Public Meeting on Draft Regulatory Guides for 50.46c – ORNL

Draft Reg Guides and determining acceptable LOCA
performance

April 29 – 30, 2015

Variation in tests inherent with RCT 300ppm bin and 7.1%ECR

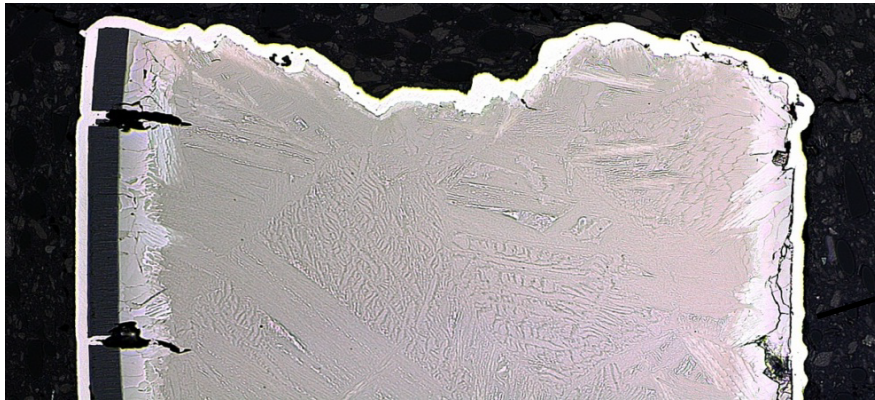
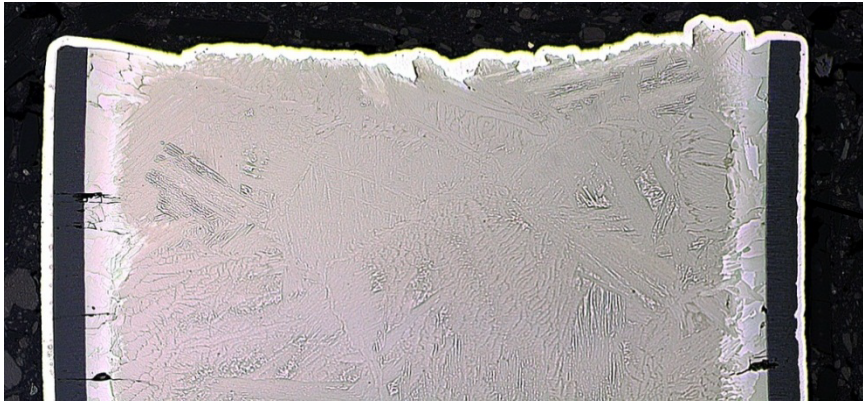
- Westinghouse has observed within-sample variation in measured strain results.
 - Similar variation in strains were also observed in the ANL and the ASTM round robin PQD results, especially as the DBT is approached.
- Given the ECR that accumulates during heat up and/or cool down, it is difficult to test using the DG protocol at 1,200°C cladding sample with 400 ppm hydrogen given the expected DBT [6% ECR, 400 ppm]
- Proposed acceptance test/analysis requirements do not address practical considerations such as within-sample variations
- The Argonne National Labs DBT appears to have been developed using curve fits to determine when the strain as a function of ECR or of hydrogen content intersects the brittle criteria.

Zircaloy-4 cladding ductility vs ECR for individual RCTs at 200 ppm target bin, PCT 1200°C

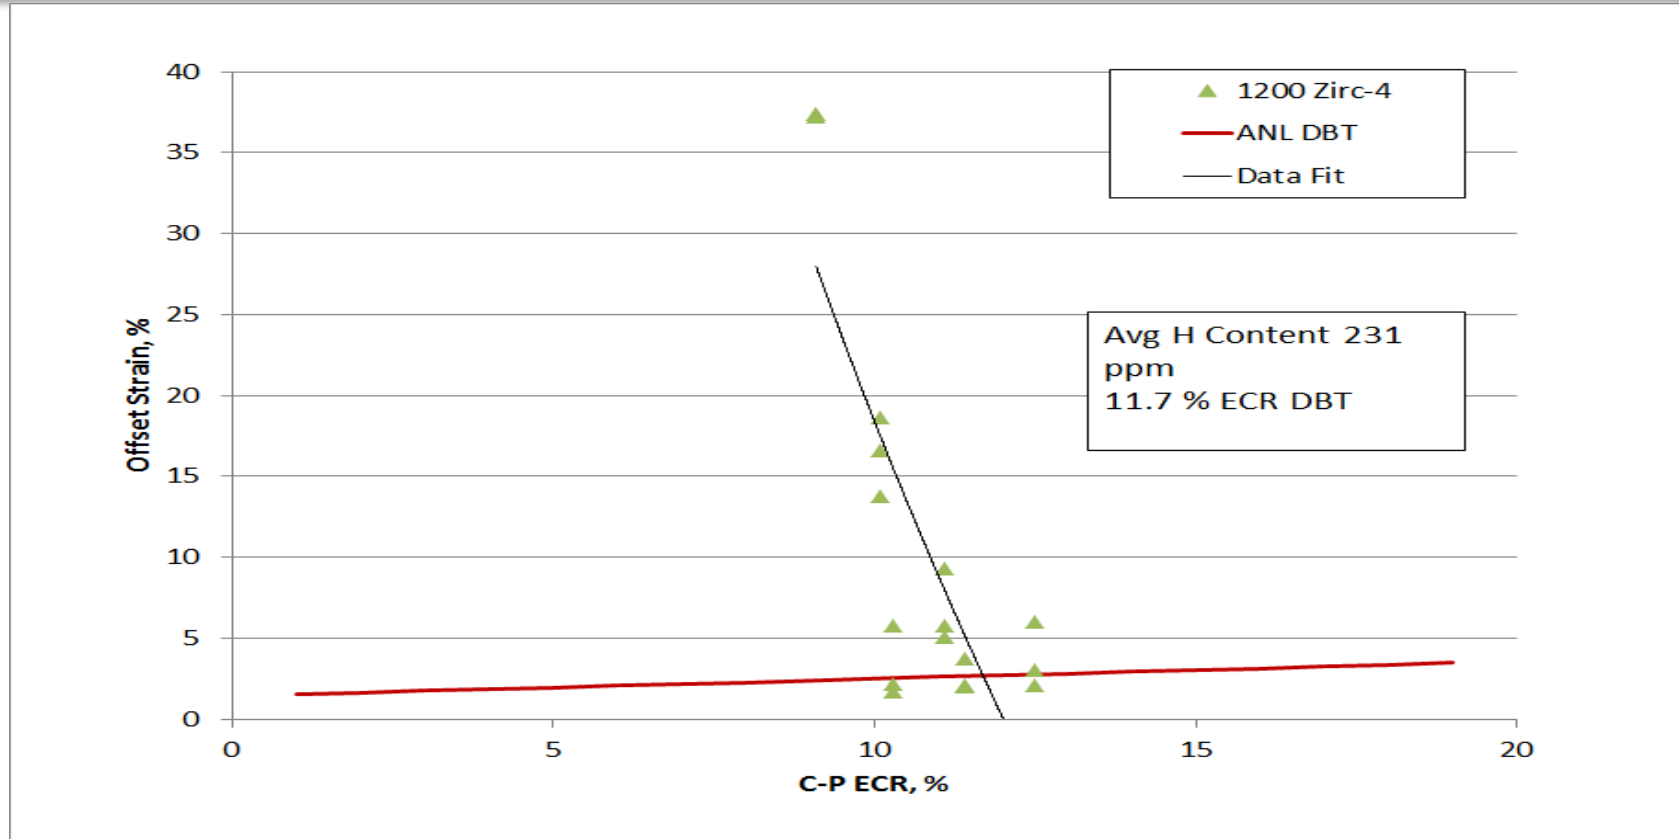
Determining DBT intersection can be difficult with narrow ECR range and shallow slope
